**RHODE ISLAND ATOMIC ENERGY COMMISSION**

Rhode Island Nuclear Science Center  
16 Reactor Road  
Narragansett, RI 02882-1165

Re: Letter dated 13 April 2010  
Docket No. 50-193

Second Response to Request for Additional Information Letter Dated April 13, 2010

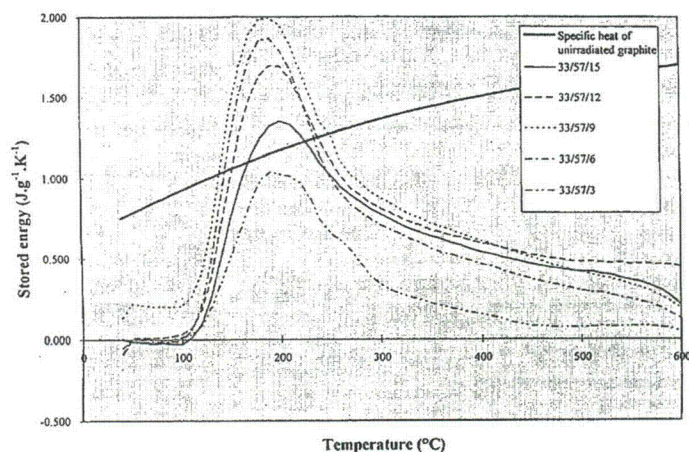
- 10.3 Section 10.2.4 discusses the thermal column experiment facility. The discussion states that cooling air is required to remove heat generated in the thermal column graphite in order to prevent the graphite from overheating. However, there is no analysis of the flow rate necessary to adequately cool the graphite, and TS 3.2.1 does not provide a set point for the safety channel associated with the thermal column. Provide an analysis of air cooling of the graphite that includes the minimum flow rate necessary to cool the graphite. Explain the basis for the graphite temperature limit of 107 degrees C. (See RAI 14.74)

The temperature limit of 107 °C is cited in the original reactor operating manual [Operation and Maintenance Manual, One-Megawatt Open Pool Reactor for Rhode Island Atomic Energy Commission, Providence, R.I., General Electric Document GEI-77793, October 1962] but no basis is

given. Since the ignition temperature of graphite is well above this temperature (ranging from approximately 400 °C upwards, depending on the specific type and form of the graphite) it is reasonable to assume the limit was placed on the graphite temperature to preclude any unexpected releases of the stored lattice energy (i.e., Wigner energy) induced by neutron irradiation.

As neutron-irradiated graphite is annealed (heated above irradiation temperatures) little or no stored energy is released below approximately 100-125 °C. A significant release peak occurs at approximately 200 °C, so limiting the RINSC thermal column graphite to temperatures below 107 °C provides a margin of nearly a factor of two to this energy release temperature. It is not credible that the entire thermal column contains lattice defects. The threshold energy for the lowest form of induced defect is approximately 1 eV (see Telling paper). After passing through the first several inches of graphite, the neutron flux in the thermal column is, as the name indicates, thermalized to an energy spectrum with a peak near 0.025 eV, which is below the threshold for inducing lattice defects. The figure below shows the energy release rate as a function of temperature (from Ref. 2 above).

The only graphite that is exposed to neutrons of energies of 1 eV or greater is the graphite in the first several inches toward the core. This section of the graphite protrudes into the reactor pool via the thermal column extension. Consequently, the cooling for this is provided by the reactor pool rather than by airflow through the thermal column. The purpose of the airflow is to prevent Ar-41 from being released into the reactor room. As a result, no airflow rate specification is needed.
